Com-ment	Letter #1141	Response
26	with seasonality dependent upon the species present (see e.g. Regulation 31- The Basic Standards and Methodologies for Surface Water - Spawning, or Colorado Section 303(d) Listing Methodology – 2008 Listing Cycle, Spawning Season DO Criteria). The DEIS and supporting documents should utilize the 7.0mg/L criterion wherever, and whenever, applicable for all D.O. profiles, analyses, presentations, and conclusions.	• Questions from EPA regarding (July 14, 2009): o The TVS – Is it a minimum 1-day average or a 15th percentile? o How to more consistently define layers? o How should the refuge concept be implemented? o What to do about seasonal/spatial variability? Note the reference by EPA to a 15th percentile as recently as July 2009. Obviously, the assessment of DO in lakes and reservoirs was in a state of flux. Since then, the WQCC adopted a method to focus predominantly on the upper two meters (0.5 to 2m) for reservoirs greater than 5 meters deep. This is very different from the methodology used in the DEIS and would lead to different results. Additionally, Horsetooth Reservoir has been classified as a warm lake since the original analysis, changing i

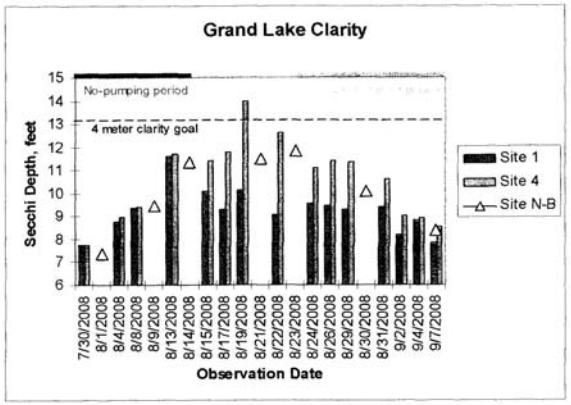
This letter is to follow up on my September 8, 2008 communication in which I summarized initial clarity data collected during the 2008 pumping trials. You'll recall the data reported in that earlier letter summarizing three sites in Grand Lake:

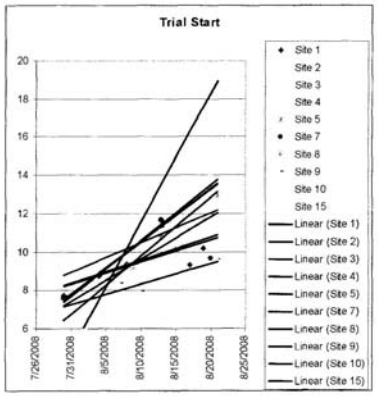
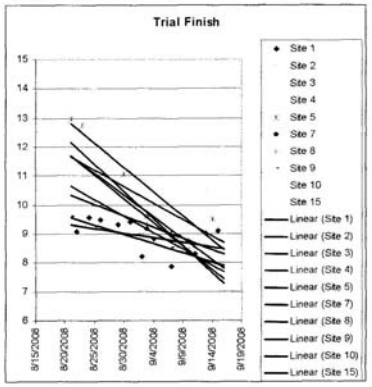
As was the case for the three sites summarized earlier, every location sampled in Grand Lake showed the same trend: Clarity improving markedly when pumping was ceased, and degrading markedly when pumping resumed.

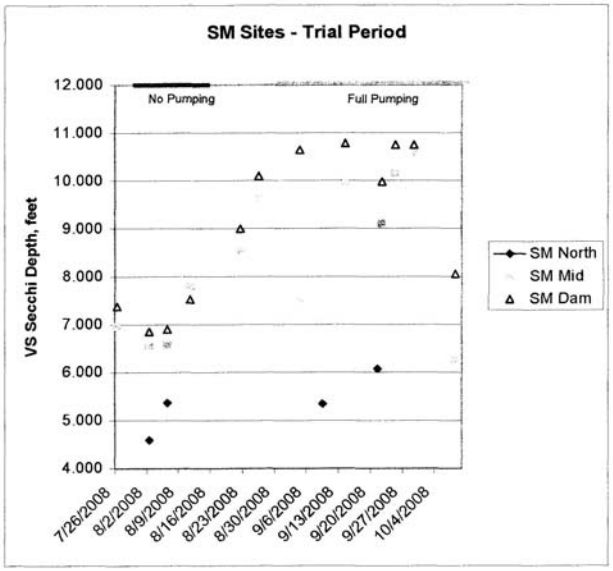
The clarity of Shadow Mountain reservoir, like Grand Lake, improved markedly during the no-pumping period at two of the three sites and eventually declined after resumption of pumping. (Data from the third site (SM North) is currently in question due to the shallow depth at that location, but I have shown all the data here to be inclusive).

Note that the clarity data above does not support the "stagnation" hypothesis, namely that the reservoir will grow more algae and become less clear if "refreshing flows" are halted. Instead the data supports an alternative hypothesis, that when the influx of nutrients from pumping is ceased, the reservoir will clear up. That it did.

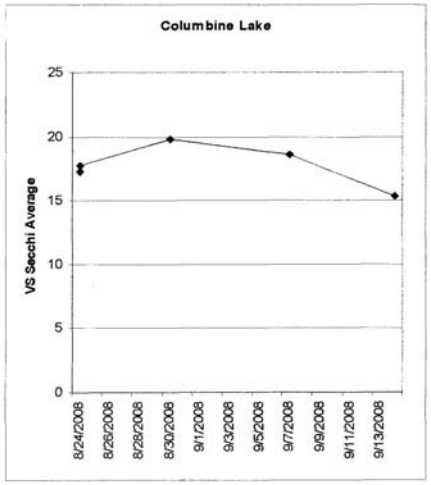
explainable by C-BT pumping, we would expect to see those same trends show up in the Columbine Lake data:

All four measurements taken on Columbine Lake during the trial period showed Secchi depths in excess of 15 feet. We should expect to achieve similar results for Grand Lake next year, assuming that the no-pumping period can be extended through August and September, as was initially proposed for 2008 by the Bureau and NCWCD.

Figure 1. Daily flows vs. mean monthly flows
(USGS Colorado River at Windy Gap, near Granby, CO gage - #09034250)

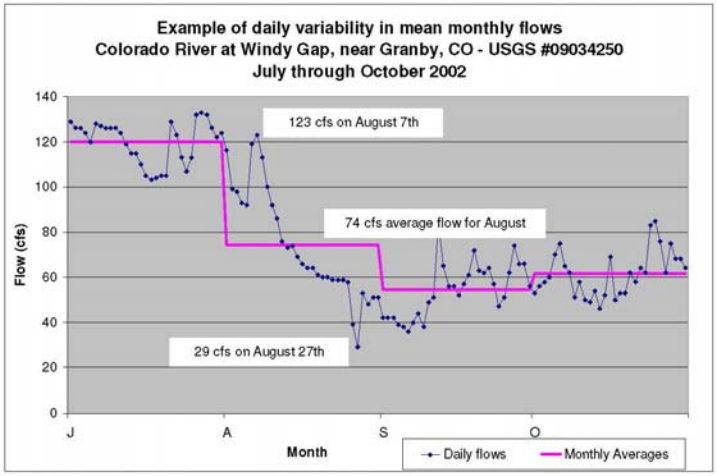
to its reliance on data from removed gages, the use of disaggregated monthly flows to evaluate daily impacts of the various WGFP alternatives is flawed for at least two reasons. First, the use of long-term averages to represent daily flow conditions in a highly variable river like the upper Colorado is inappropriate and leads to highly inaccurate results. Figure 1 (attached) illustrates this problem. In this example, "disaggregating" the mean monthly flow of 74 cfs based on an average daily flow distribution is unlikely to capture the true extreme high (123 cfs) and extreme low (29 cfs) flows that were actually experienced on the Colorado River in August 2002. Flows within this section of the Colorado River vary widely, even when comparing average years to average years or wet years to wet years. Because the daily pattern of flows within a given month is unlikely to be the same from year to year, long-term averages are not representative of true daily flow conditions. Second, the approach fails to model the temporal sequencing of annual flow events (wet/average/dry years). For example, the DEIS states that WGFP diversions would not increase in dry years. However, dry years create deficits in reservoir storage and diversions to fill these deficits are likely to increase in average or wet years following dry years. The right approach would be to evaluate impacts of the various project alternatives in a series of average or wet years that occur in the period following a dry year. In addition, the output from the habitat analysis is summarized in numerous exceedence charts, but these charts cannot be used to evaluate seasonal impacts of the various project alternatives. For example, what are the impacts of back-to-back dry years followed by an average to wet year on habitat availability during the most critical days in August? Relatively small impacts during the most critical times of the year can have devastating implications for aquatic species that are already at risk from low stream flows and elevated water temperatures. Consequently, the hydrologic model is inadequate as a tool to predict and assess impacts on aquatic resources.

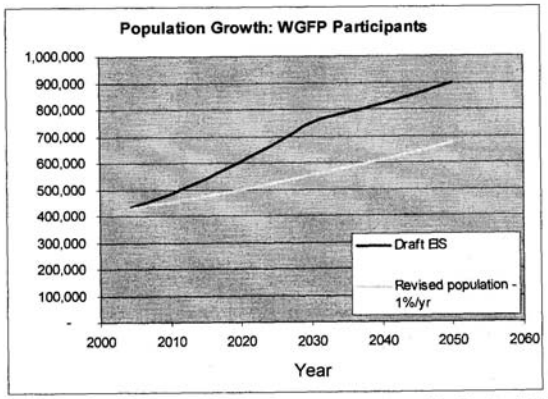
**Figure 1. Population growth for WGFP participants, as projected by the Draft EIS (blue) and under a revised scenario of 1% annual growth rate (yellow).** *WRA's calculations throughout these comments use the population growth estimates used by BOR in the Draft EIS. However, we note here that these population projections are fatally flawed and cannot support the proposed project.* As noted in the prior section, population over-estimations compound over time: an inaccurately high projected growth rate in the first several years of any period compounds errors in later-year projections. If population grows more slowly than the DEIS projects—which all evidence indicates that it will—future water demands will be correspondingly lower than our re-calculated estimates.	
7	**Proposed Per Capita Water Use is Arbitrary:** With just a few paragraphs of explanation, the Purpose and Need and DEIS proposes 217 gallons per person per day (gpcd) as a "reasonable average" of system-wide water use against which to compare WGFP beneficiaries.[34] The figure is averaged from year-2000 data that underlie both the first phase of Colorado's recent Statewide Water Supply Investigation (SWSI) and a paper from the University of Utah. The proposed average is arbitrary, capricious, and unreasonable. It is a fatal flaw in the DEIS that must be revised. The proposed average water use rate is flawed for several reasons: 1. The water use rate in the Purpose and Need is derived from a single year of data, rather than a range of years; [34] Purpose and Need, p. 34. 10	7. The purpose of the discussion of comparable water use rates in the Purpose and Need Report is not to develop estimates of water use for various Participants, adjusting for all other factors, but to provide a more generalized comparison to place the water use of the Participants in the context of other water providers to determine reasonable water use levels. The DEIS provides water use comparisons based on the published data available at the time of development of the Purpose and Need Report. The SWSI and University of Utah reports did not contain multiyear historical data, but did include data and information useful for these analyses, in terms of recent data for communities of similar characteristics. Several shortcomings of these data sources are acknowledged, but the data extracted for use are either Colorado-specific or includes communities comparable in size and climate to the Participants. See responses to Comment Nos. 8 through 12 for further elaboration.

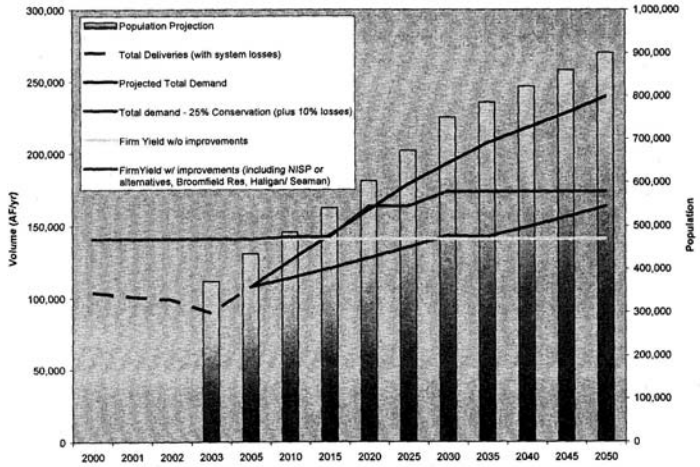
Furthermore, if population grows more slowly than expected, total water demands may be significantly lower. Using the same assumptions about conservation savings and a revised annual population growth rate of 1%, total water demands in 2030 are 105,300 AF/yr, *slightly less than the current demand*. In 2050, participants' water demands grow to 122,000 AF/yr, well below today's firm supplies.

Figure 2. Population growth (right axis; uses DEIS proposed rates of population growth), water demands, and water supply projections (left axis) for WGFP participants. If NISP or its potential alternatives, Broomfield Reservoir, and the Halligan/Seaman Reservoirs are constructed, firm supplies will exceed projected demands through 2050 without the construction of the WGFP.
